**From:** [Murray, Susie](#)  
**To:** [TREVOR HAM](#); [Gurney, Cleve](#)  
**Subject:** RE: [EXTERNAL] 1801 Ridley Ave. Family Apartments  
**Date:** Friday, October 14, 2022 1:14:00 PM  
**Attachments:** [24\) Landsape and Lighting-057 CP-IPLA.pdf](#)

**From:** TREVOR HAM <only1remy@yahoo.com>  
**Sent:** Wednesday, October 5, 2022 5:53 PM  
**To:** Murray, Susie <SMurray@srcity.org>  
**Subject:** [EXTERNAL] 1801 Ridley Ave. Family Apartments

## RIDLEY TYPICAL SECTION (NORTH)

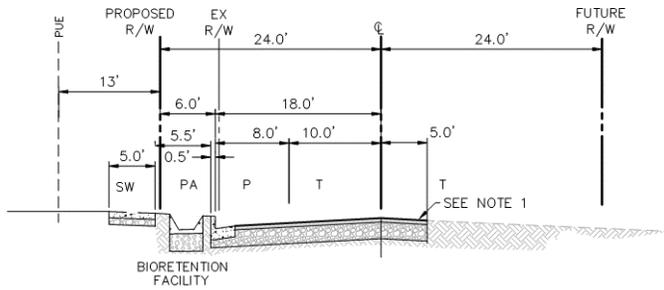
Will Ridley Rd. be widened ? I've seen fire trucks and ambulances get blocked from the rugby field at Comstock

Ridley Ave will be improved to a minor street standard along the project frontage (half street width improvements consist of a 10' travel lane, 8' parking lane, 6' planter strip, and 5' sidewalk).

1. A COMPLETE 20' ALL WEATHER WIDTH IS REQUIRED ALONG PROJECT FRONTAGE FOR THE MOST NORTHERLY 200'±LF OF RIDLEY AVE.
